Access Compliance Report

Public Rights-of-Way

Intersection ID: 50590	Main Street: GREEN_GRASS_RD	Cross Street: SITKA_CT	Location: W
ADA ID: C6E56DE4A5BC	Ramp Type: Perp	Initial Pass/Fail: Fail	Overall Compliance: No
Severity Score: 35			
Codes/Mitigation Info/Possible Solution		Field Measurements/Component Compliance

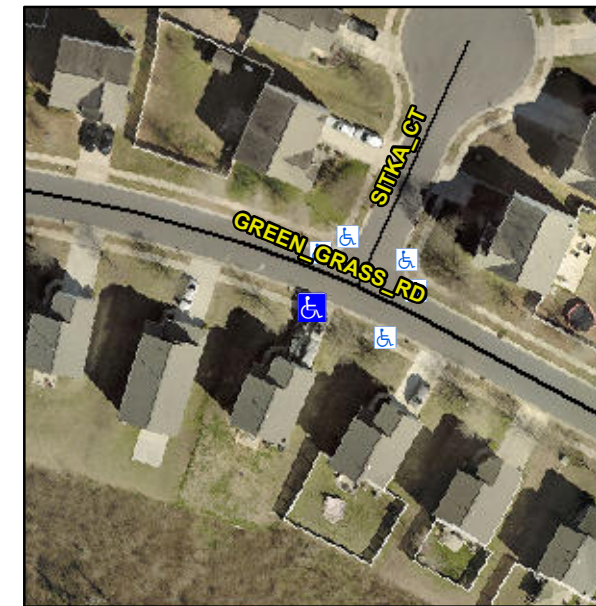
R304.5.1, R304.2.2, R304.5.3

Compliance	Description	Data	Compliance	Description	Data
N/A	Ramp Length (in)	48.0	No	Ramp Slope (%)	13.1
No	Ramp Width (in)	47.5	No	Ramp XSlope (%)	4.7
N/A	Flare Type LT	N/A	N/A	Flare Type RT	N/A
N/A	Flare Slope LT (%)	N/A	N/A	Flare Slope RT (%)	N/A
N/A	Flare Traversable LT?	N/A	N/A	Flare Traversable RT?	N/A
N/A	Landing Length (in)	N/A	N/A	DWS Provided?	N/A
N/A	Landing Width (in)	N/A	N/A	DWS Contrast?	N/A
N/A	Landing Slope (%)	N/A	N/A	DWS Length (in)	N/A
N/A	Landing X Slope (%)	N/A	N/A	DWS Full Width?	N/A
N/A	Landing Curb? (Y/N)	N/A	N/A	DWS Offset (in)	N/A
N/A	Shared Landing?	N/A			
N/A	Gutter Ponding?	N/A	N/A	Gutter Slope (%)	N/A
N/A	Gutter Lip Ht (in)	N/A	N/A	Gutter X Slope (%)	N/A
N/A	Painted X Walk1?	No	N/A	Painted X Walk2?	N/A
	X Walk 1 Direction	To NE		X Walk 2 Direction	N/A
N/A	X Walk 1 Width (in)	N/A	N/A	X Walk 2 Width (in)	N/A
	X Walk 1 Slope (%)	2.4		X Walk 2 Slope (%)	N/A
	X Walk 1 X Slope (%)	3.4		X Walk 2 X Slope (%)	N/A

Remove & Replace Entire Ramp.
